BUREAU OF LAND MANAGEMENT			EXPIRES: March 31, 2007
SUNDRY NOTICES AND REPORTS ON WELLS			5. Lease Serial No.
Do not use this form for proposals to drill or to re-enter an abandoned well. Use Form 3160-3 (APD) for such proposals			NM0418220A-SHL NM0405444A-BHL 6 If Indian, Allottee or Tribe Name
	JBMIT IN TRIPLICATE	RECLIVED	
	2101.12	2000	7. Unit or CA Agreement Name and No
1a. Type of Well Oil Well Gas Well Other.			
			8 Well Name and No.

2. Name of Operator NMOCD ARTESIA			Todd 26C Fed Com 12H
			9 API Well No. 3 1 1 2 46 A 4 4 4 4 4 4 4 4 4 4 4 4 4 4 4 4 4
3. Address and Telephone No			30-015-36827
20 N. Broadway, Oklahoma City, Ok 73102-8260 405-235-3611			10. Field and Pool, or Exploratory
4 Location of Well (Report location clearly and in accordance with Federal requirements)*			Ingle Wells; Delaware
330' FNL 1980' FWL 1980' FWL 1980 C SEC 26 T23S R31E			11. County or Parish State
BHL: 2310' FNL-& 1980' FWL PP:550' FNL & 1980' FWL Eddy NM

## Todd 26C Fed Com 12H 30-015-36827 Devon Energy Production Company, LP December 9, 2009 Conditions of Approval

## 13-5/8" x 5,000 psi BOP Stack

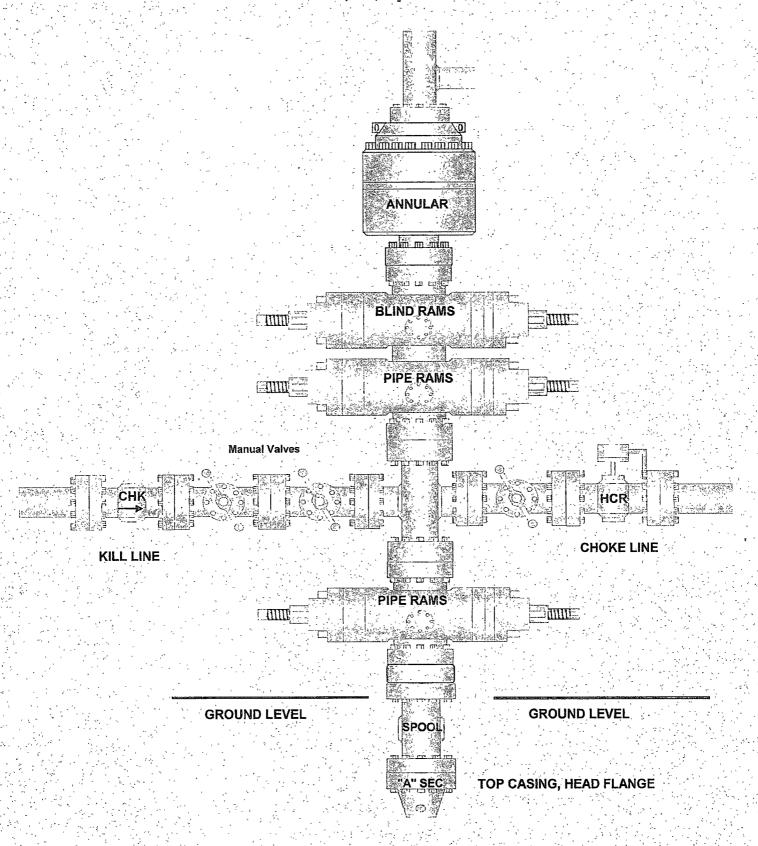
Formation below the 9-5/8" shoe to be tested according to Onshore Order 2.III.B.1.i. Test to be done as a mud equivalency test using the mud weight necessary for the pore pressure of the formation below the shoe (not the mud weight required to prevent dissolving the salt formation) and the mud weight for the bottom of the hole. Report results to BLM office.

- 1. Minimum working pressure of the blowout preventer (BOP) and related equipment (BOPE) required for drilling below the surface casing shoe shall be 3000 (3M) psi.
- 2. Minimum working pressure of the blowout preventer (BOP) and related equipment (BOPE) required for drilling below the 9-5/8" intermediate casing shoe shall be 5000 (5M) psi. 5M system requires an HCR valve, remote kill line and annular to match. The remote kill line is to be installed prior to testing the system and tested to stack pressure.
